RICHMOND COMMUNITY SCHOOL
Richmond High School: Mechanical Modernization Project
LWC Commission No. 20104.02

ADDENDUM #04
October 5, 2021

3 NEW WORK ROOF PLAN - UNIT C
SCALE: 1/16" = 1'-0"

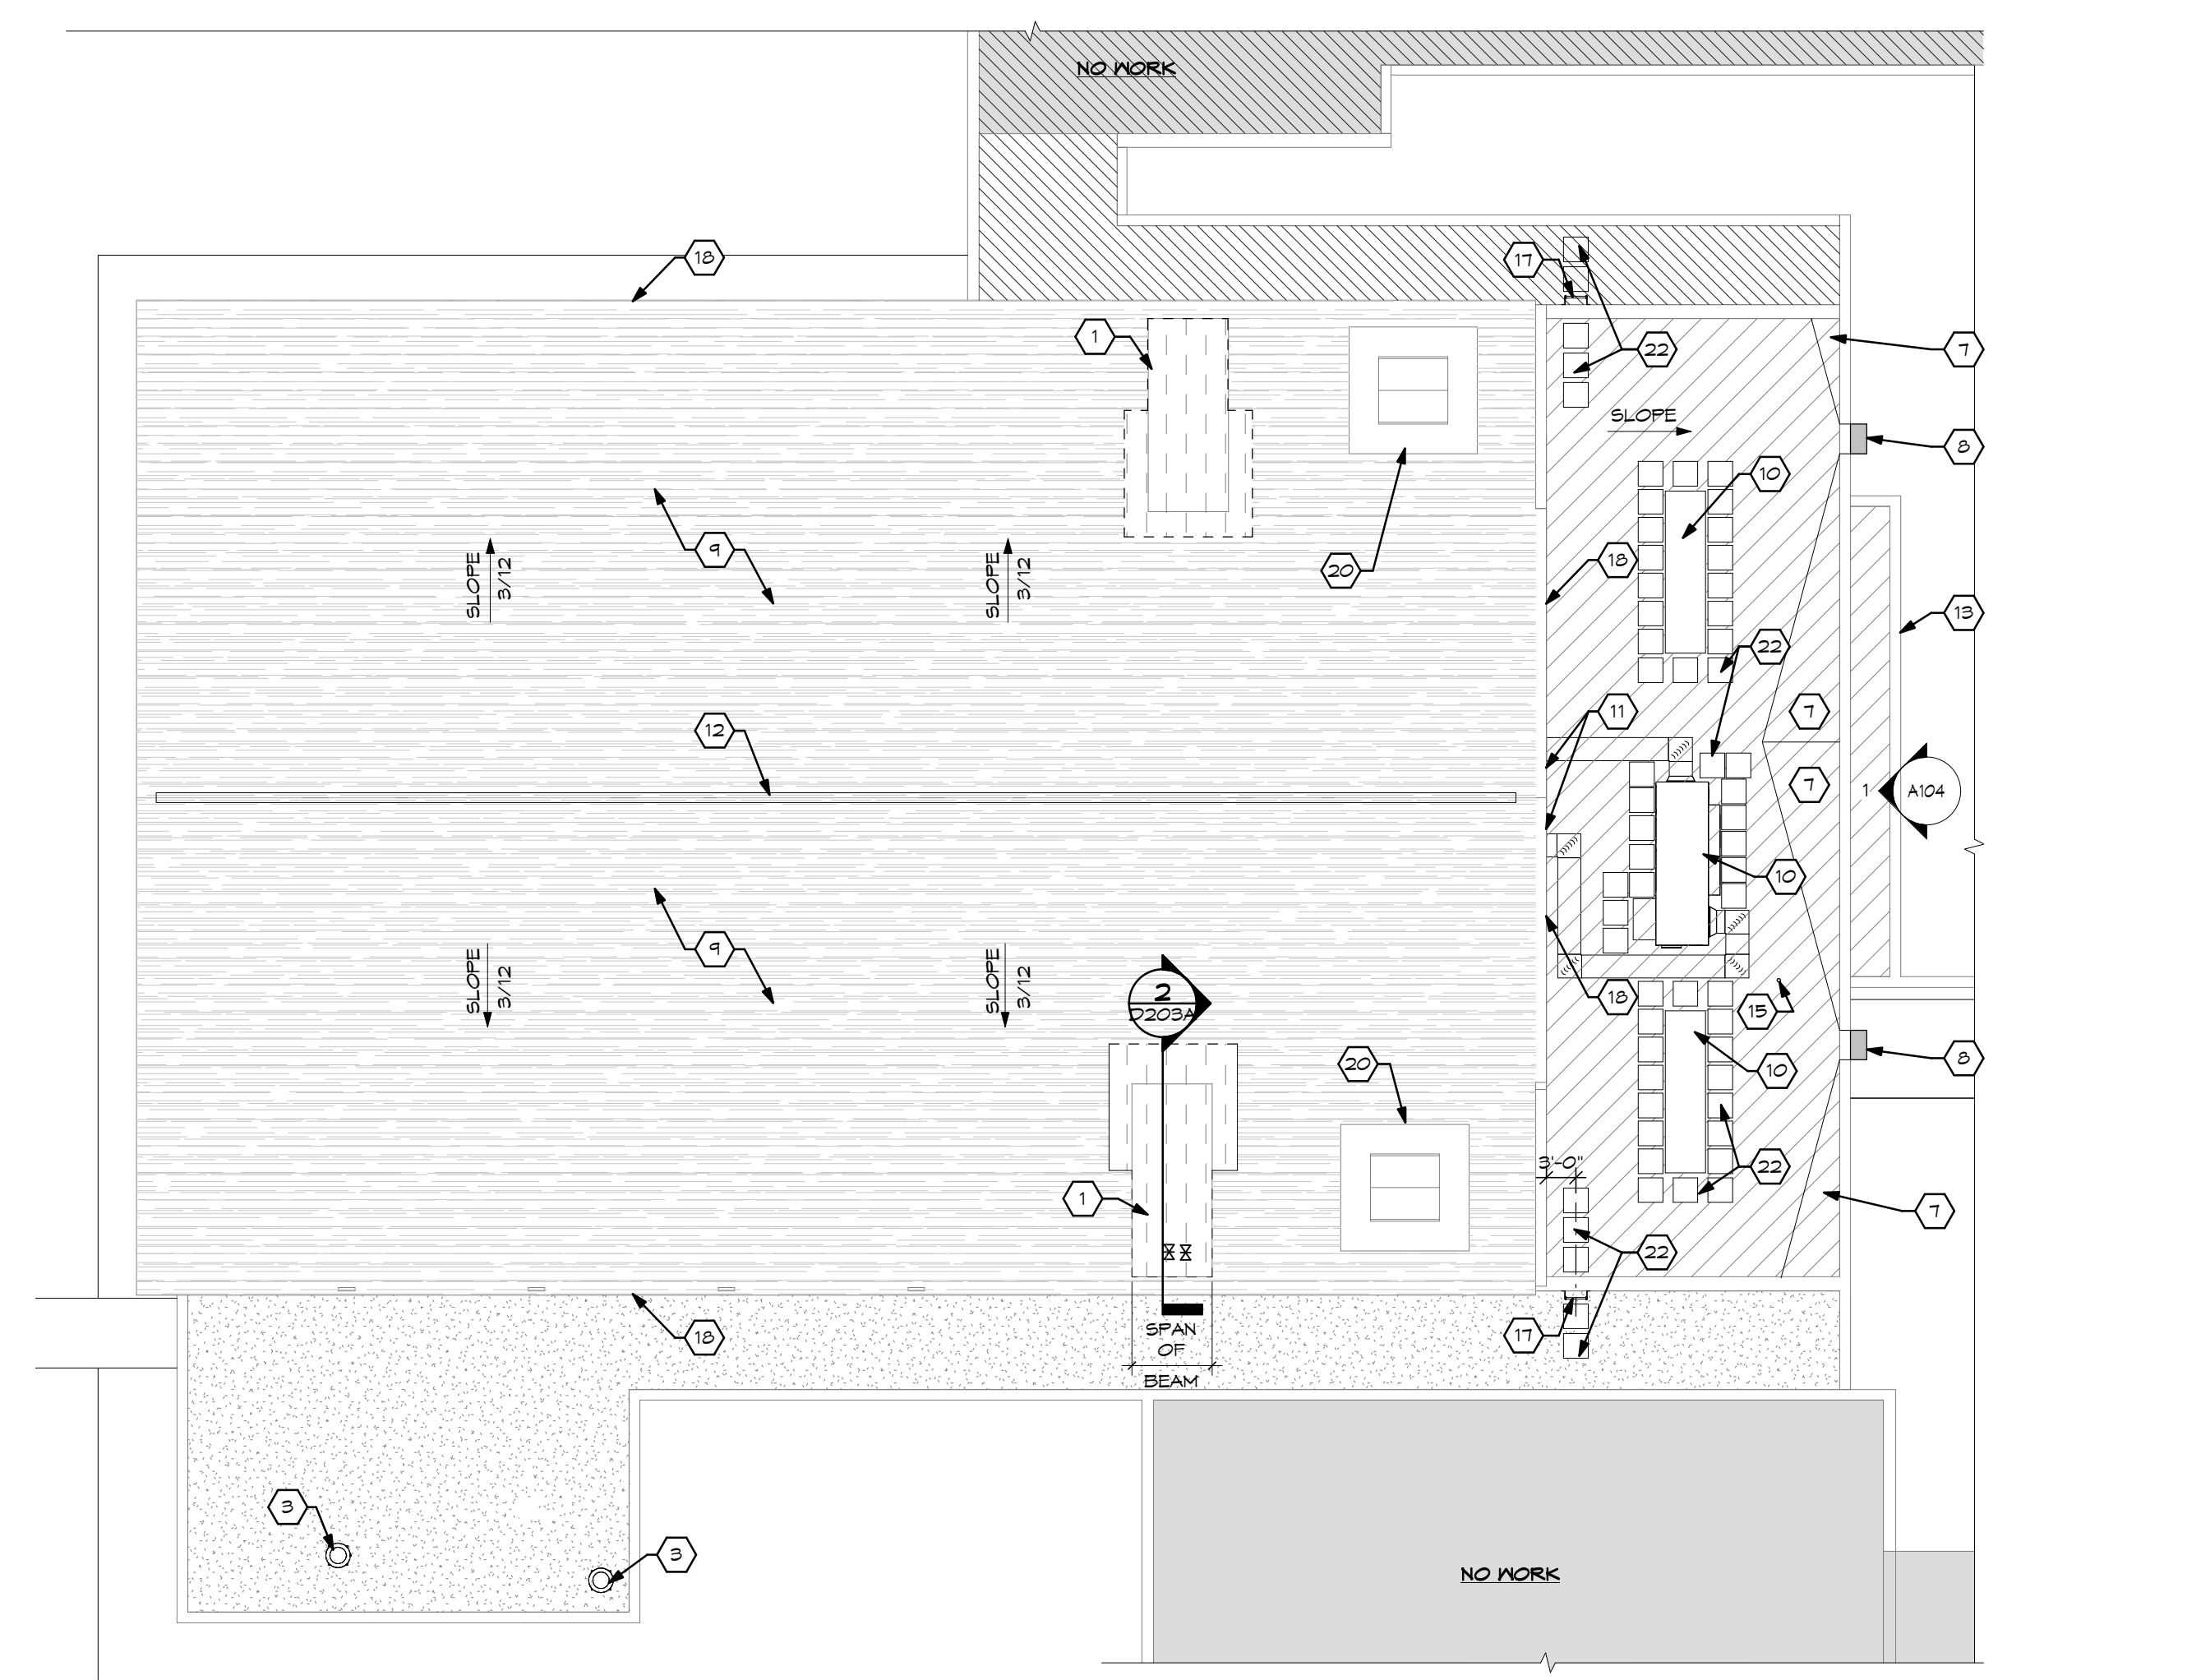
ITEM NO.4 Drawing A901

- A. Revised sheet note #13
- B. Added Sheet Note #22

2 BOILER HOUSE - GAS MAIN ALTERNATE NO. 13
SCALE: 1/4" = 1'-0"

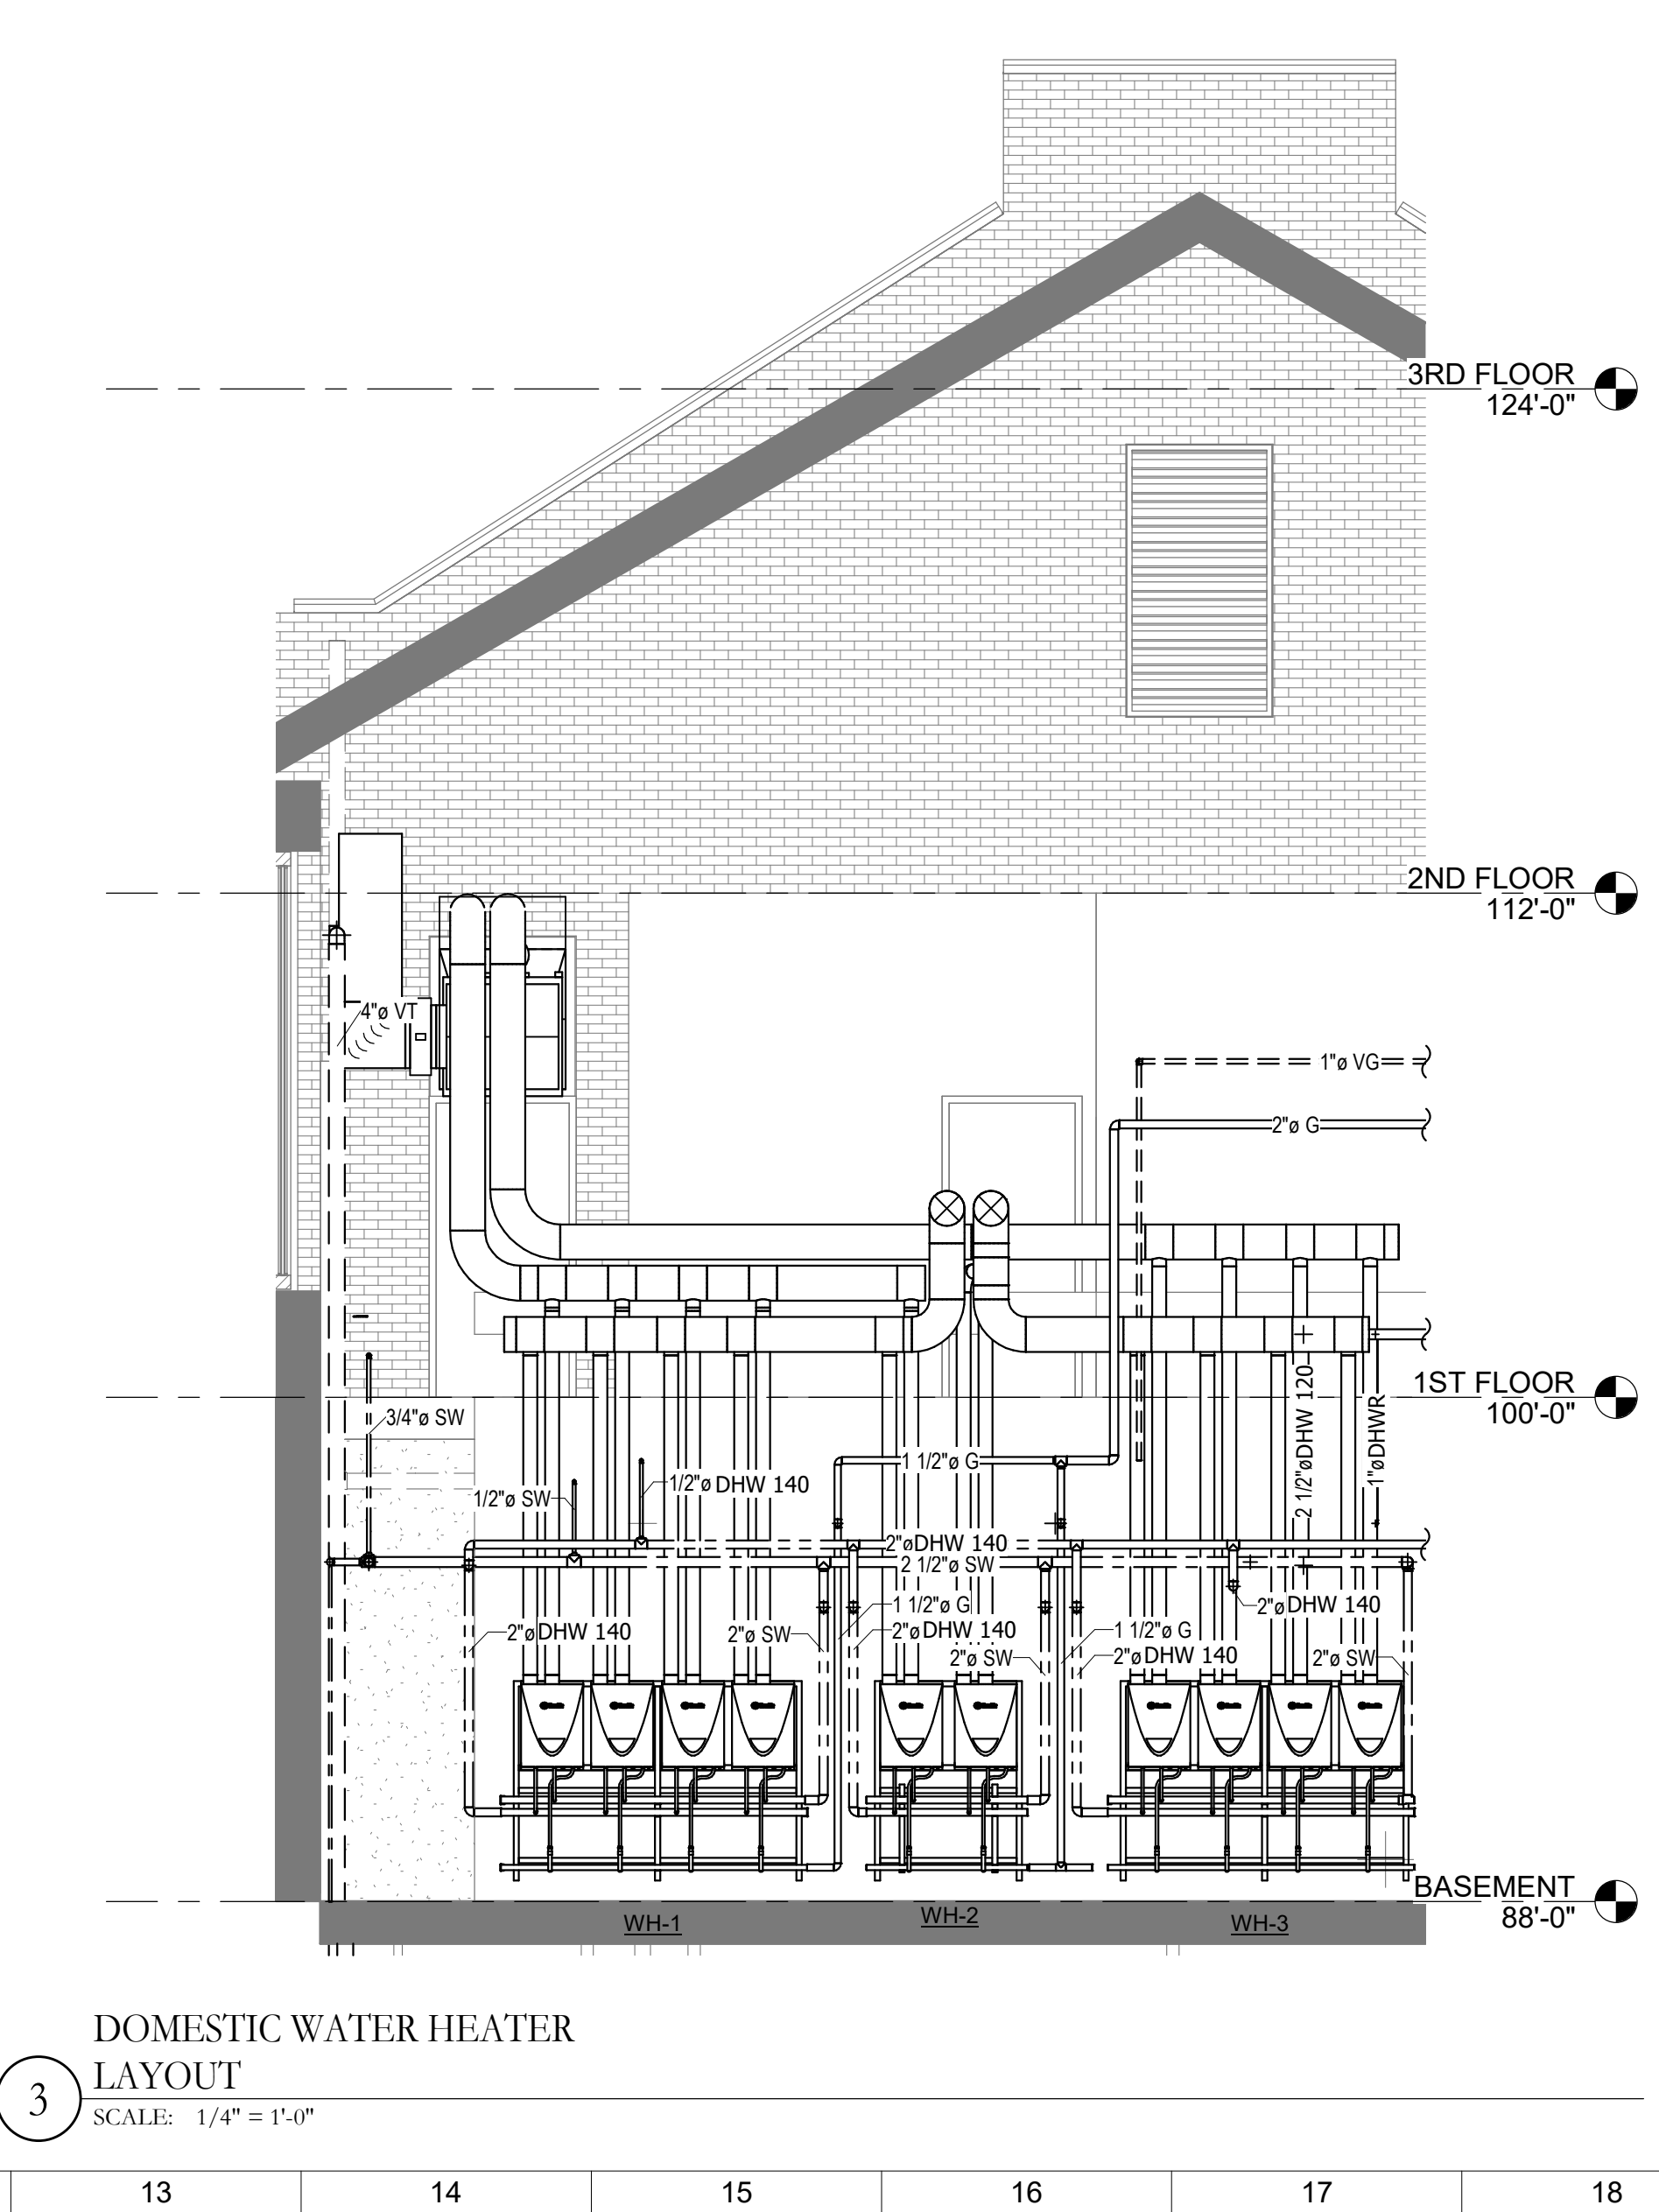
ITEM NO.6 Drawing P202

- A. Added clarification to work defined within Base Bid versus Alternate No. 13 for gas main.

- b. Alternate Bid – Include all material, labor, and any other costs associated with new Gas Main to existing boiler house per Sheet P202, View 2 – BOILER HOUSE – GAS MAIN ALTERNATE No. 13.
